**FINAL DECISION DOCUMENT
FOR THE NORTH BOUNDARY SYSTEM
IMPROVEMENTS INTERIM RESPONSE ACTION
AT THE ROCKY MOUNTAIN ARSENAL**

COMMENTS ON THE PROPOSED DECISION DOCUMENT FOR THE
NORTH BOUNDARY SYSTEM IMPROVEMENTS INTERIM RESPONSE ACTION
JANUARY 1989

RESPONSES TO COMMENTS BY THE U.S. ENVIRONMENTAL
PROTECTION AGENCY, REGION VIII, ON THE PROPOSED
DECISION DOCUMENT FOR THE NORTH BOUNDARY
SYSTEM IMPROVEMENTS INTERIM RESPONSE ACTION
JANUARY 1989

STATE COMMENTS ON THE PROPOSED DECISION DOCUMENT FOR THE
NORTH BOUNDARY SYSTEM IMPROVEMENTS INTERIM RESPONSE
ACTION AT THE ROCKY MOUNTAIN ARSENAL, JANUARY 1989

Figure 3. Generalized Alluvial Groundwater Flow Across RMA
 (NOTE: Arrows are indicative of direction of flow and do not represent flow quantities.)

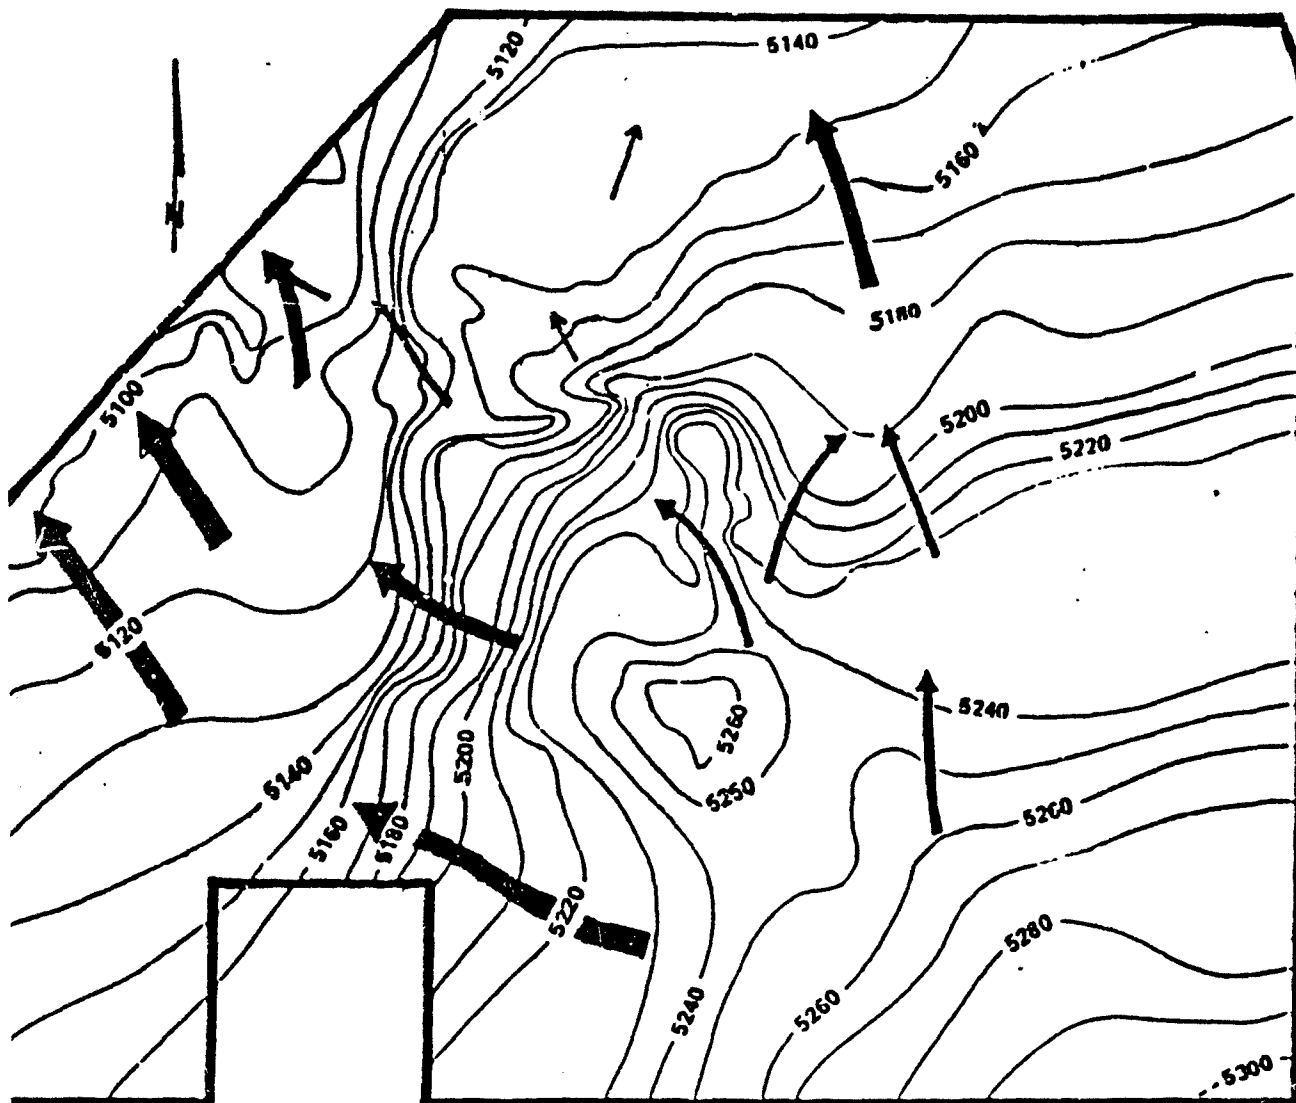
2. Page 5, Figure 3.

The arrows representing flow towards the northern Arsenal boundary incorrectly imply that the groundwater flow from the vicinity of Basin F is similar in magnitude to the groundwater from the vicinity of First Creek. The groundwater flow from the First Creek vicinity is much greater than the flow from the vicinity of Basin F. The arrow roughly in vicinity of Basin C and Basin F is also disproportionately large. In fact, recent hydrogeological investigations in this area provide evidence that this flow is almost nonexistent. Replacing this entire figure with a figure showing more up-to-date information is recommended.

RESPONSE: The arrows on Figure 3 have been reduced in size to de-emphasize the flows north of Basin F and from the vicinity of Basin C. The referenced source has been deleted. A note has been added to indicate that arrows are indicative of direction of flow and do not represent flow quantities.
